PARK PLACE SUBDIVISION

APPLICATION NUMBER 17 DATE November 20, 2003
APPLICANT Park Place Subdivision
REQUEST Subdivision

DETAIL SITE PLAN

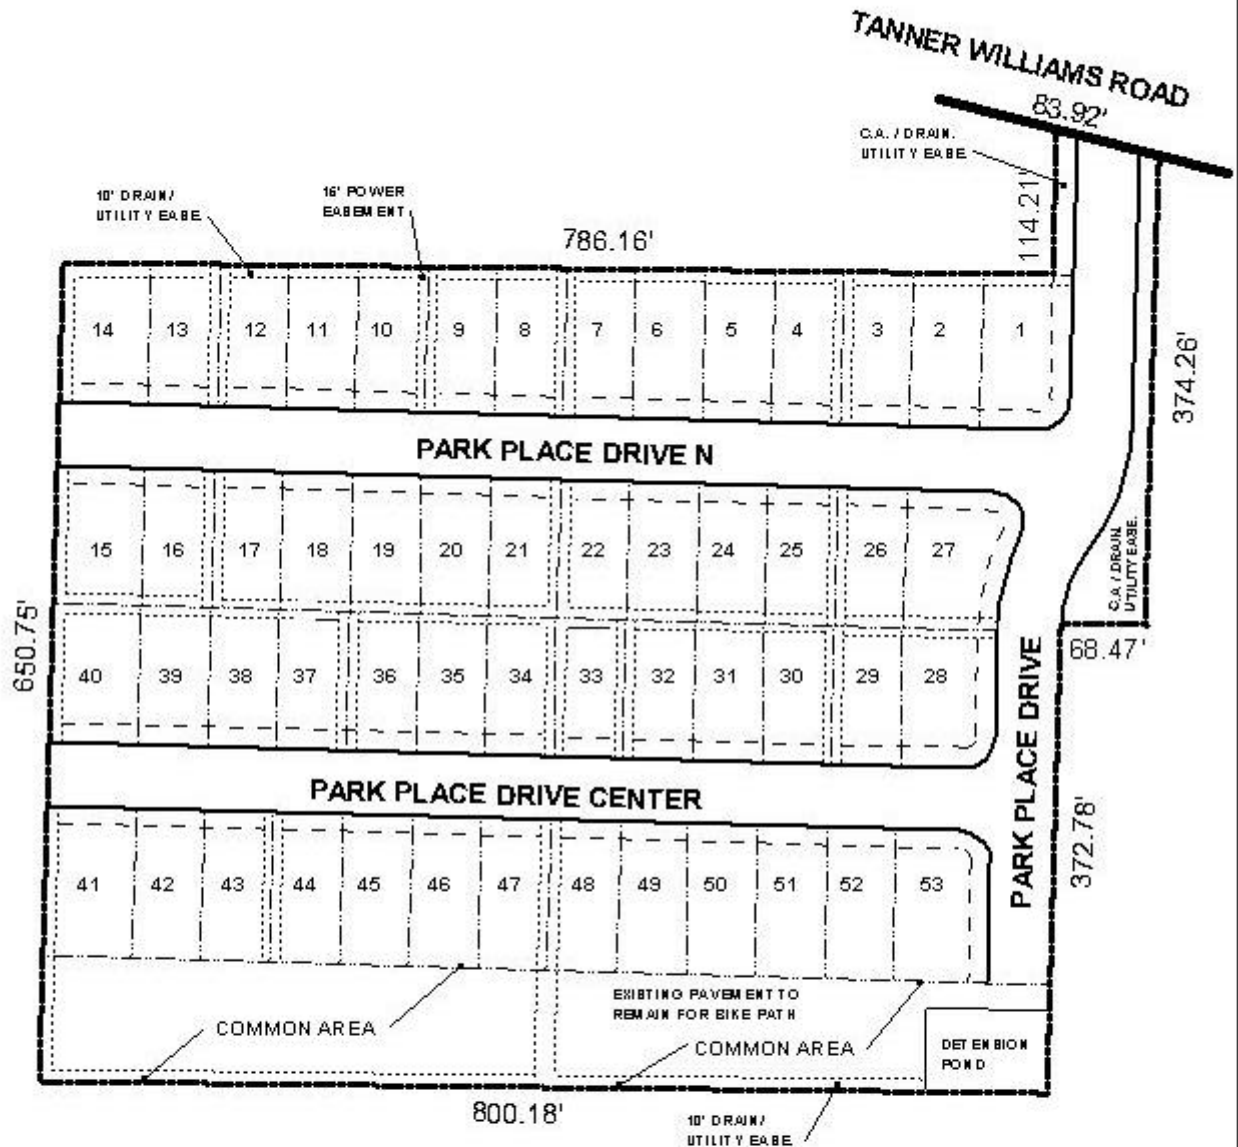
The site fronts Tanner Williams Road, a planned major street, which has an existing right-of-way of 60 feet; the Major Street Plan requires a 100-foot right-of-way. Therefore, the dedication of adequate right-of-way to provide 50' from the centerline of Tanner Williams Road, should be required.

A note on the final plat stating that lots located on a corner (Lots 1, 27, 28 and 53) are allowed one curb cut each, with the size, location and design to be approved by County Engineering, should be required. Section V.B.6 of the Subdivision Regulations states that a closed end street shall not be longer than 600-feet. As proposed, the subdivision complies with the Regulations by providing street stubs to the West. However, the streets are approximately 700' long; therefore, the requirement of a temporary turnaround should be required. Additionally, the construction of the proposed streets should be paved to County standards.

As illustrated on the plat, combined, the lots have a total of 8.02 acres and 1.87 acres of open/green spaces. The lots average 6,050 square feet, and thus do not comply with lot area and lot width (V.D.2.) of the Subdivision Regulations. However, overall lot information and open/green spaces provides for a total of 9.89 acres at the site. This will more than offset those lots that do not meet the minimum 7,200 square feet lot size as required by V.D.2. of the Subdivision Regulations.

Common areas are shown on the plat, thus the placement of a note on the final plat stating that maintenance of all common areas shall be the responsibility of the property owners, should be required.

There is a note on the preliminary plat stating that zero lot line setbacks are proposed on some lots. A note should be placed on the final plat stating that lots with zero building setbacks will not share a common lot line with any other lots, nor will the zero building setback be located along the perimeter of the site. The illustration of the typical building limits for all lots in the site, should be shown.

The plat meets the minimum requirements of the Subdivision Regulations and is recommended for Tentative Approval subject to the following conditions: 1) the dedication of adequate right-of-way to provide 50' from the centerline of Tanner Williams Road; 2) the placement of a note on the final plat stating that lots located on a corner (Lots 1, 27, 28 and 53) are limited to one curb cut each, with the size, location and design to be approved by County Engineering; 3) the construction of the proposed streets to paved County standards; 4) the placement of a note on the final plat stating that lots with zero building setbacks will not share a common lot line with any other lots and will not be located along the perimeter of the site; 5) the illustration of the typical building limits for all lots on the final plat; 6) the placement of a note on the final plat stating that any lots which are developed commercially and adjoin residentially developed property must provide a buffer, in compliance with Section V.A.7. of the Subdivision Regulations; and 7) the placement of a note on the final plat stating that maintenance of all common areas is the responsibility of the property owners.
